ADDENDUM NO. 1

PGA Golf Management Program Academic Learning Lab Construction

State Project No. H17-9623-CB | Architect's Project No. 22.304.00

M-101

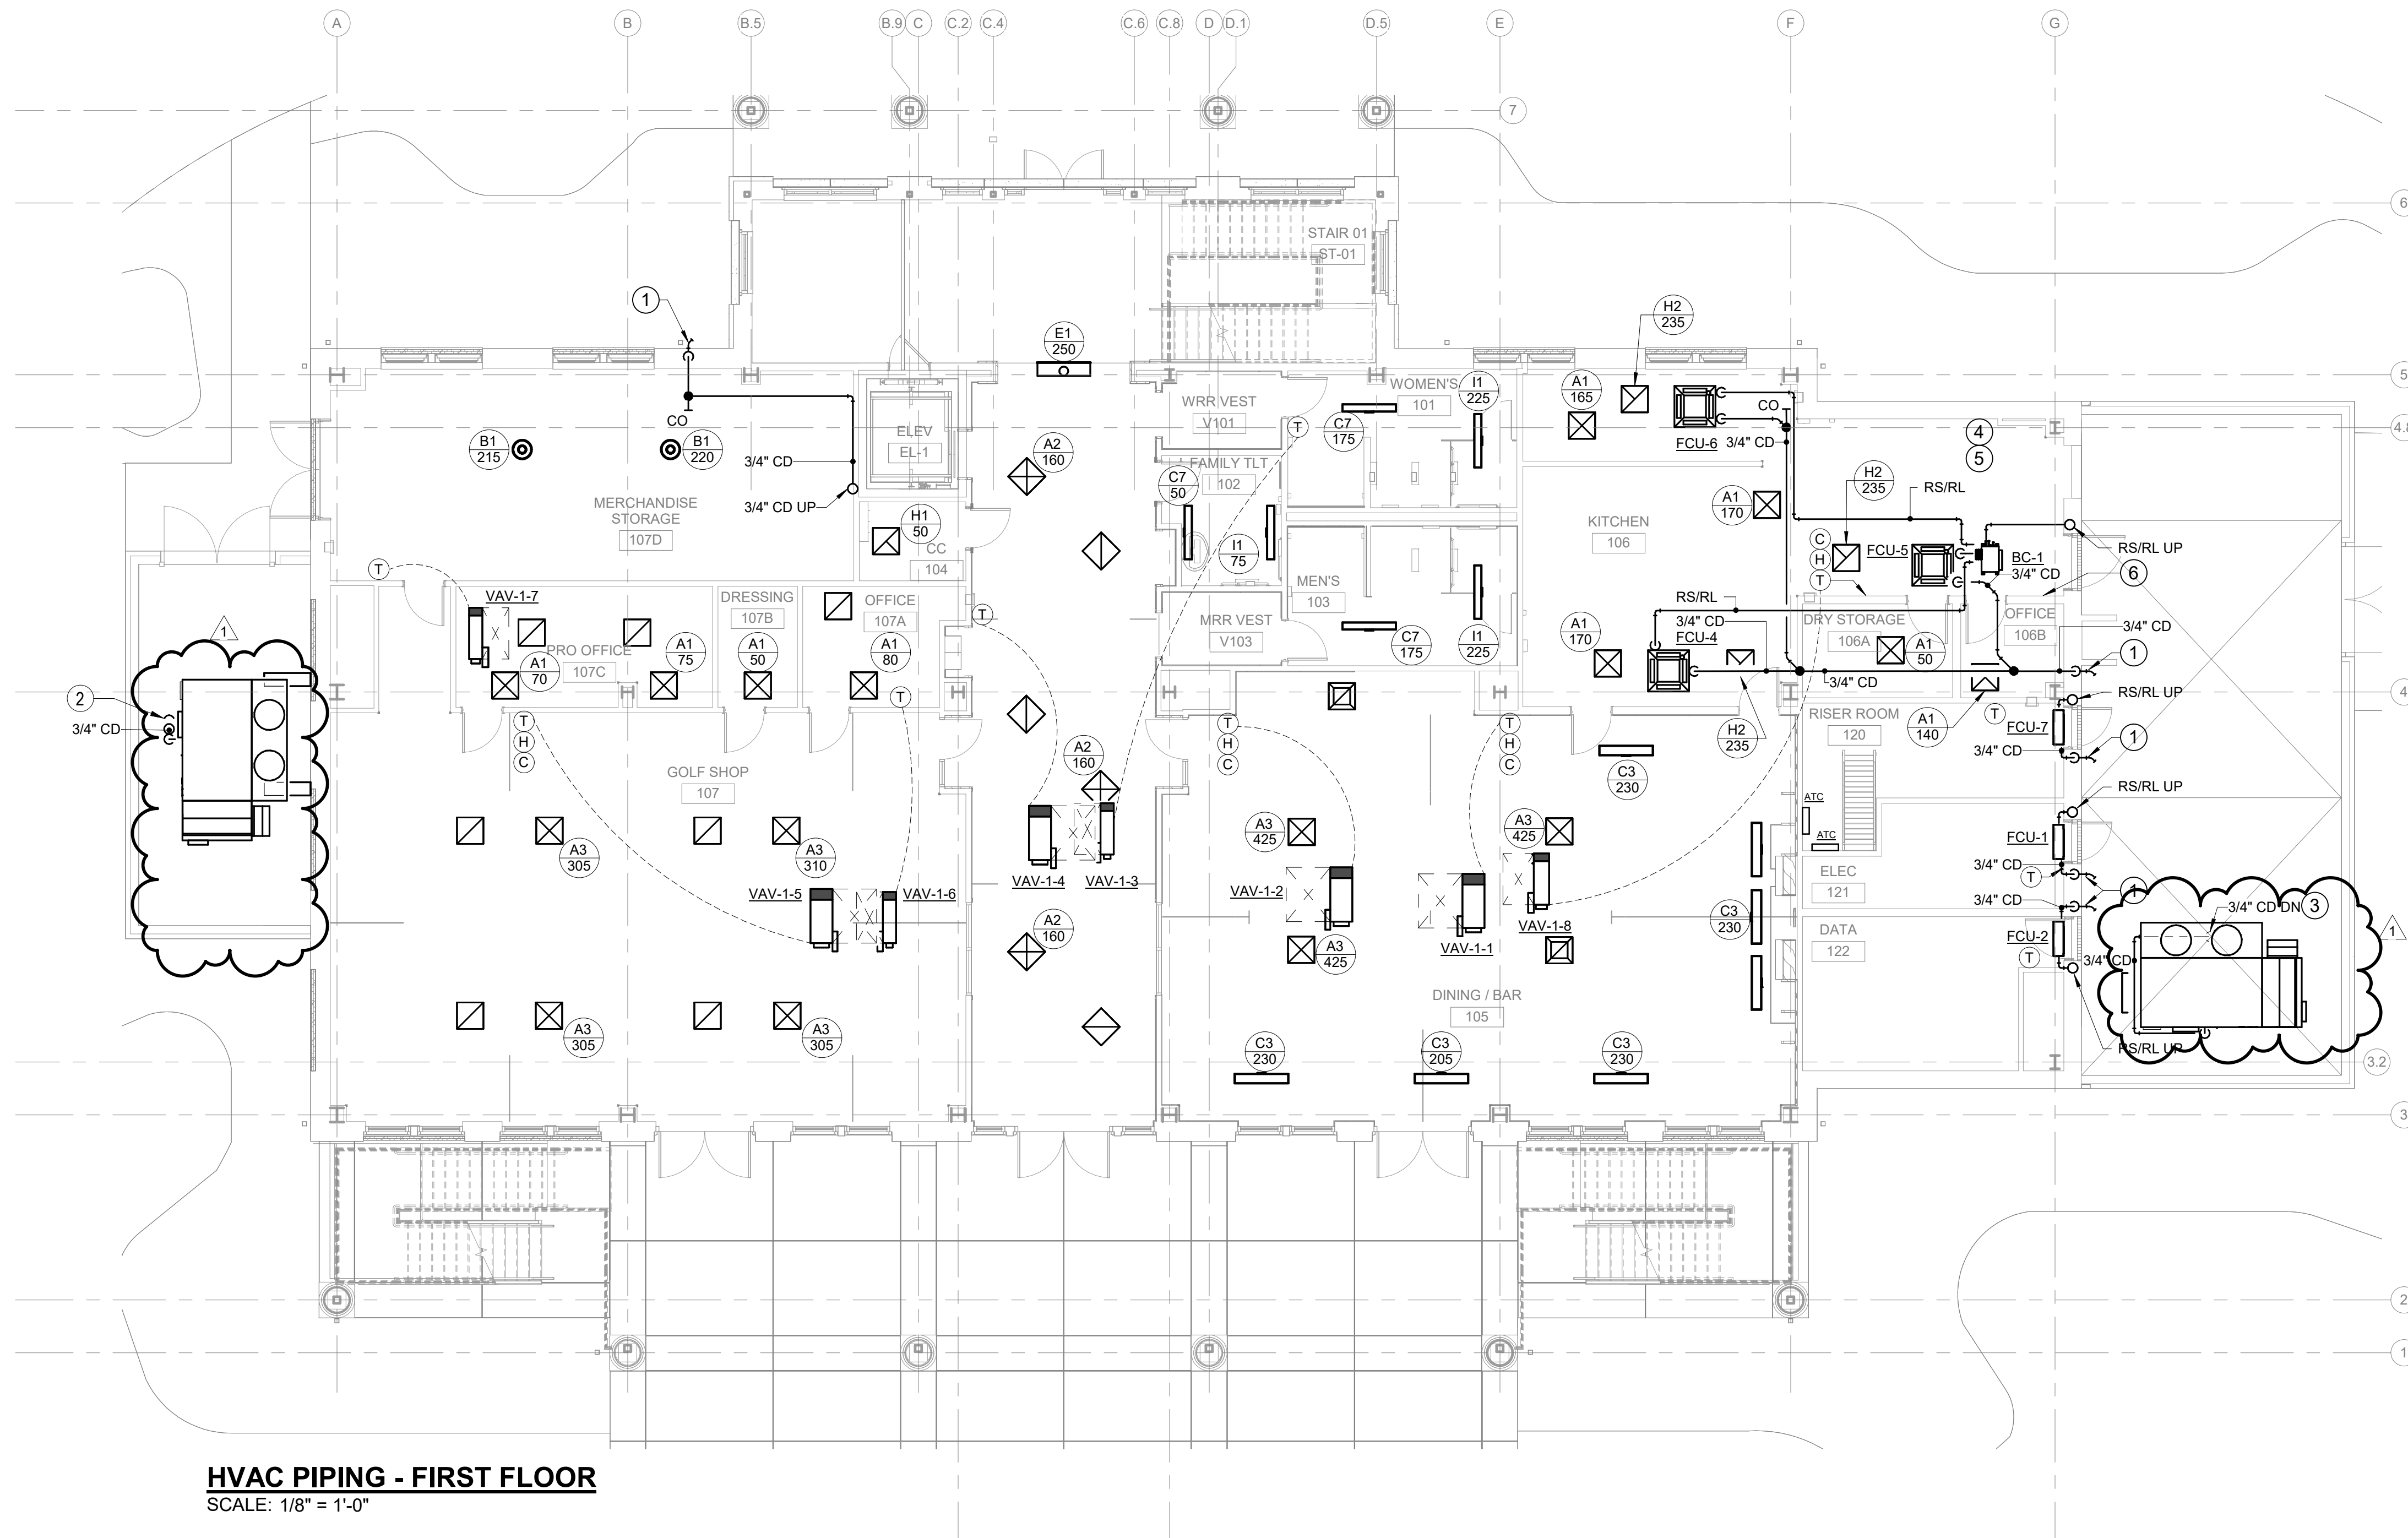
- 1-2 Sheet M-101 – DUCTWORK – FIRST FLOOR:
 - a) Updated physical size of air handling units AHU-1 and AHU-2
 - b) Removed 48"x48" outside air intake duct from AHU-1 to louver.
 - c) Removed 48"x48" outside air intake duct from AHU-2 to louver.
 - d) Updated drawing note 2.

M-201

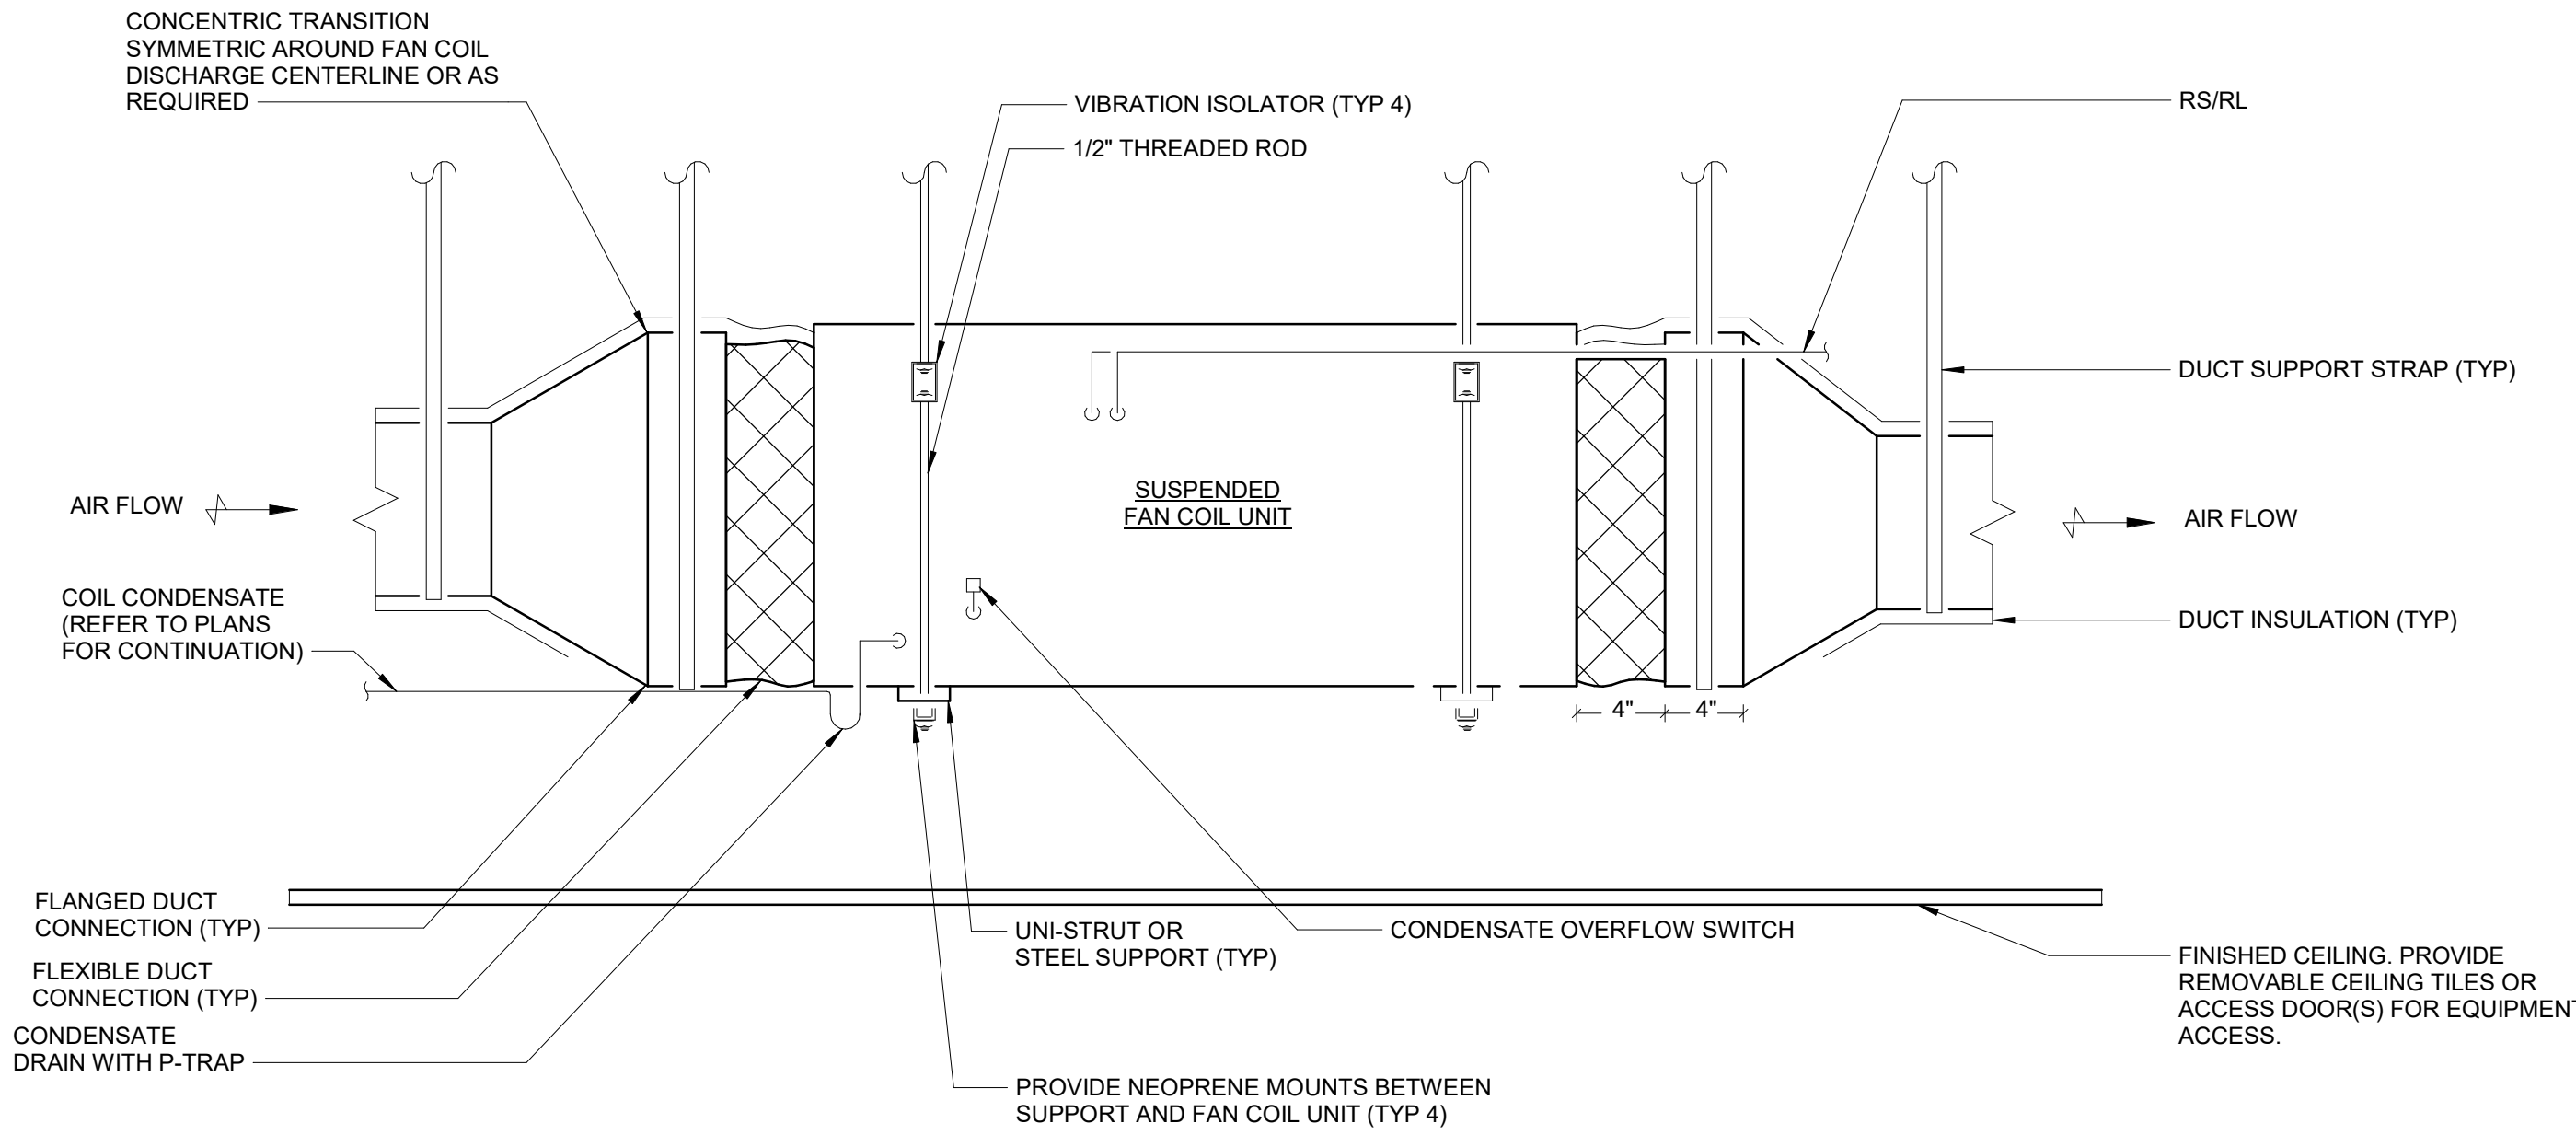
- 1-3 Sheet M-201 – HVAC PIPING – FIRST FLOOR:
 - b) Updated physical size of air handling units AHU-1 and AHU-2.
